**BEFORE THE PUBLIC UTILITY COMMISSION
OF OREGON**

LC 70

2019 Integrated Resource Plan.

OPENING COMMENTS OF SWAN
LAKE NORTH HYDRO, LLC

SWAN LAKE BLOCK SCHEDULE REQUIRED FOR A 2026 COMMERCIAL OPERATION DATE

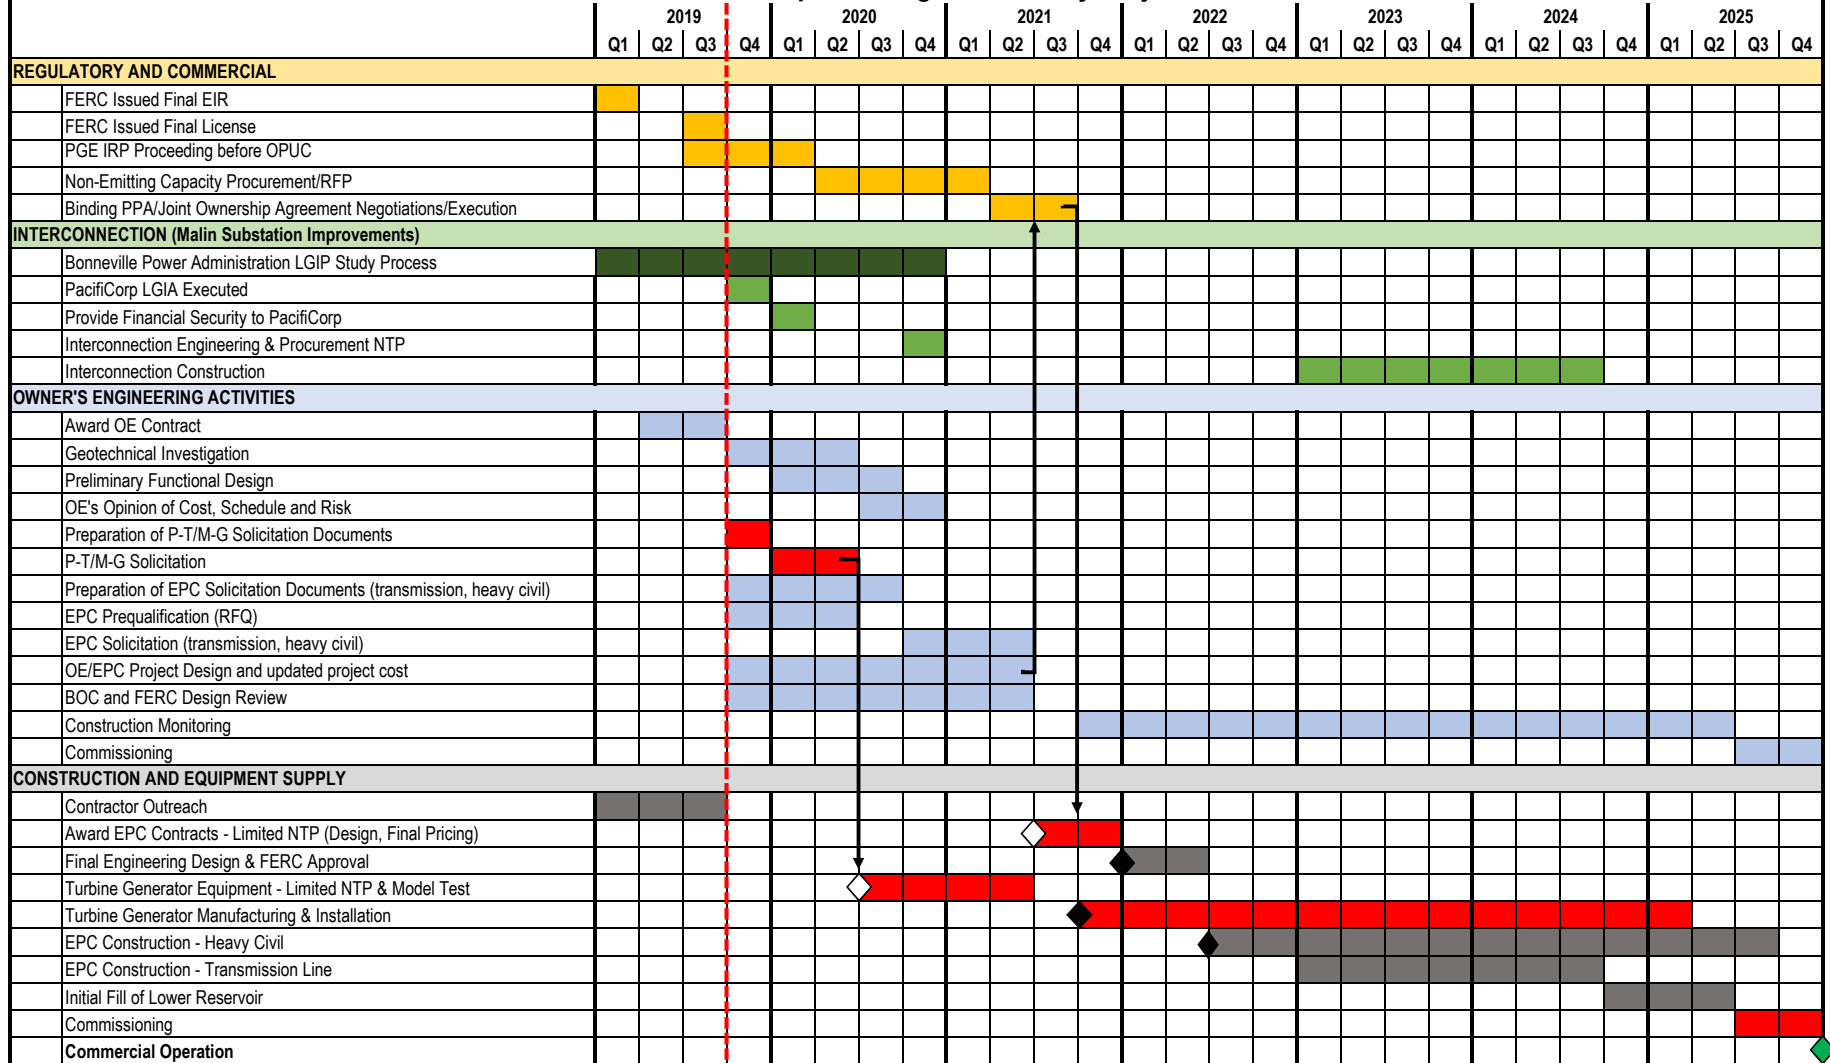
In order to provide the Commission and PacifiCorp with a clearer picture of the rationale for expanding PacifiCorp’s action plan window, Swan Lake has provided a high-level schedule for Swan Lake as Appendix A to these Comments. If, for example, Swan Lake were to be targeted to compete to serve PacifiCorp’s capacity needs beginning in 2026, a definitive power purchase agreement or ownership agreement would have to be finalized by the end of Q3 2021,

which would allow enough time for Swan Lake to conduct geotechnical investigations, perform preliminary functional design, procure necessary equipment, contract for detailed design engineering, obtain financing, construct the project, and achieve commercial operation in time to meet PacifiCorp's 2026 capacity need. For this reason, pumped storage resources do not easily fit within the Commission's typical IRP/RFP process.
